Docket No. 50-245  
B13400

Millstone Nuclear Power Station, Unit No. 1  
Proposed Changes to Technical Specifications

Millstone Nuclear Power Station, Unit No. 1  
Description of Proposed Changes to Technical Specifications

FIGURE 5-1 MINIMUM GADOLINIUM LOADING, AS Gd203, IN MINIMUM OF THREE FUEL RODS PER ASSEMBLY LATTICE-TYPE

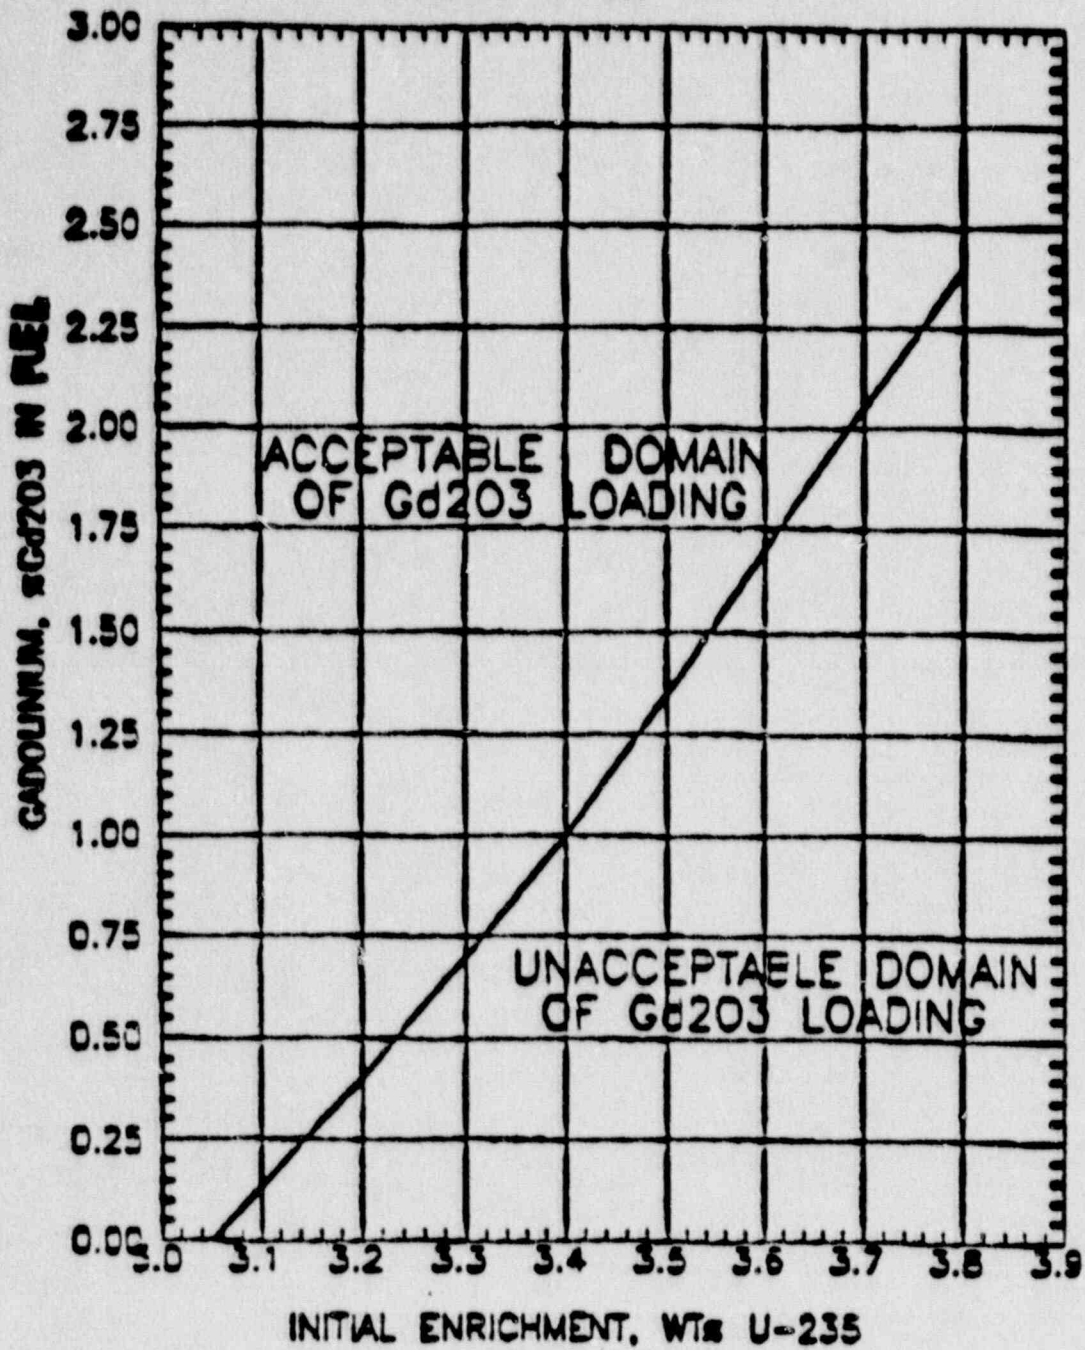
This section has been revised to state that the  $K_{eff}$  of the spent fuel storage pool shall be less than or equal to 0.90 if the minimum gadolinium loading in a minimum of three fuel rods per fuel assembly lattice-type versus the initial U-235 enrichment is within the acceptable region of Figure 5-1.

2. Figure 5-1, Minimum Gadolinium Loading

This new Figure has been added to Section 5.0 to designate the acceptable gadolinium loadings per fuel type as referenced by revised Section 5.5.B.

- A. The new fuel storage facility shall be such that the  $K_{eff}$  dry is less than 0.90 and flooded is less than 0.95.
- B. The  $K_{eff}$  of the spent fuel storage pool shall be less than or equal to 0.90. This  $K_{eff}$  value is satisfied if the minimum gadolinium loading in a minimum of three fuel rods per fuel assembly lattice-type versus the initial U-235 enrichment is within the acceptable region of Figure 5-1.
